HDC-2025-00012

Address: 625 Liberty Street

District: Old Fairgrounds Historic District

**Proposal:** Replace rooftop railing, install deck and door and lighting at existing signage.

Annotated image indicating extent of proposed roof deck, uncovered door opening (left), and proposed infill for window (right) (Applicant)

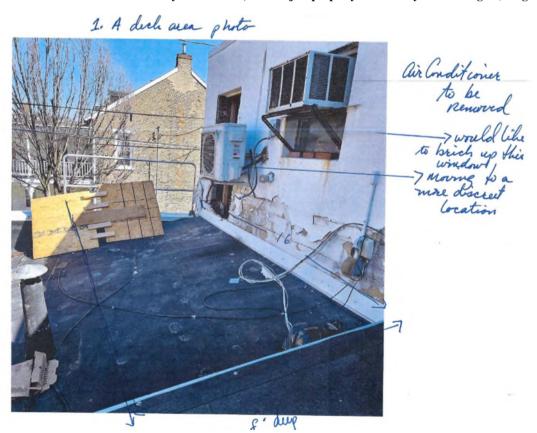
- **Rear Railing:** If approved, it would be preferred for the existing metal pipe railing to be removed and replaced with the wood railing; having both may be redundant. Installing a wood rail would create balance on the streetscape, as on the other side of Park Street, 623 Liberty has a rear second floor porch with wood railing. More information would be helpful to understand the proposed extent of the proposed railing would it go the length of the deck, or the whole length of the exterior wall? It would be appropriate/preferred for the railing to extend the length of the deck.

- **Roof Deck:** The extent of the proposed deck (8' from the rear wall) is in proportion with other typical historic rear balconies and porches.
- **Proposed Door:** A full view fiberglass door in a previous doorway is appropriate per the guidelines. A full-light storm door is also appropriate.

- **Proposed Window Infill:** The second window at the rear is a replacement window in an opening that had been previously reduced from its original size. Given the extent of exterior modifications and alterations on the entire structure, infilling this window would not have a negative effect on the streetscape.

- The wood railing replaces the existing pipe railing (as allowable by code official), and extends the length of the deck.
- The second floor window infill is finished in such a way as to match the finish of the exterior wall around it.
- Sign light fixture is a simple fixture directed only at the sign, avoiding excessive illumination of areas outside the sign, and fixture information is submitted to staff for approval.
